FACILITY CONDITION ASSESSMENT

VETERANS MEMORIAL STADIUM
CONCESSION & RESTROOM BUILDING

180 School Road
Wilton, Connecticut

Marx|Okubo Job No. 23-2104

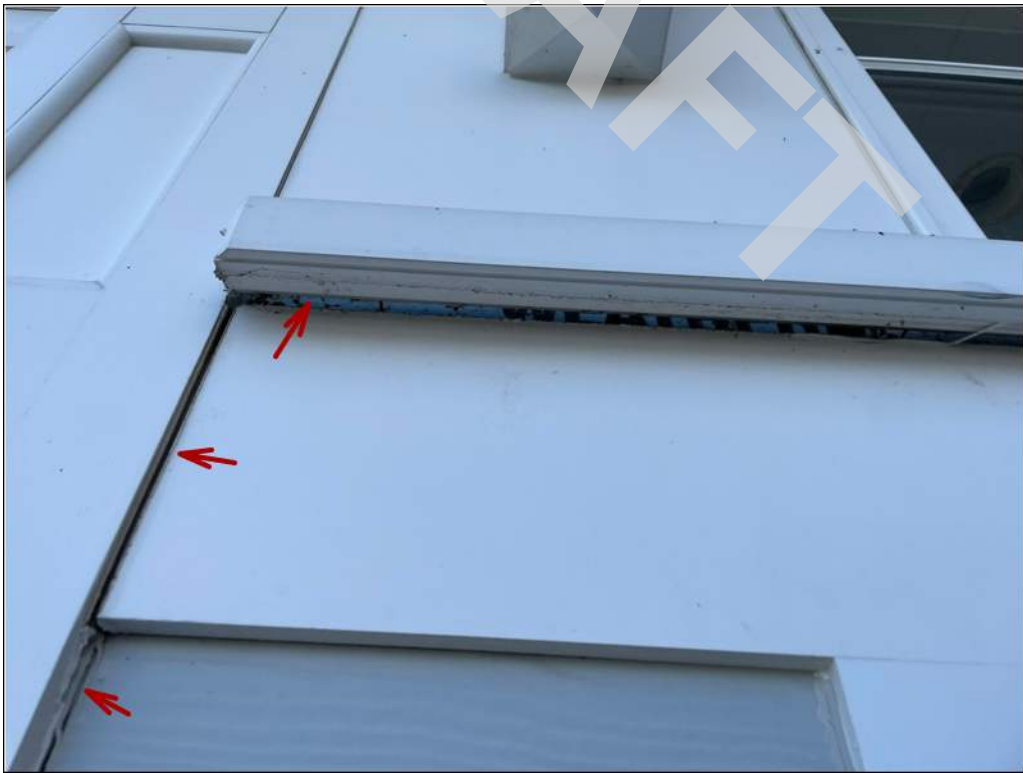
2 - Extensive cracking and vertical displacement was observed throughout the cast-in-place concrete paths.

3 - No gutters or leaders are provided throughout the building.

4 - Differential movement noted between fiber cement trim and panels throughout the building enclosure.

5 - Recessed lighting metal rings have corroded due to water and moisture exposure.

6 - Fiber cement base has displaced and detached from the facade.

10 - The restroom door threshold exceeds the allowable height.

11 - A lowered counter area is not provided at the concession stand.
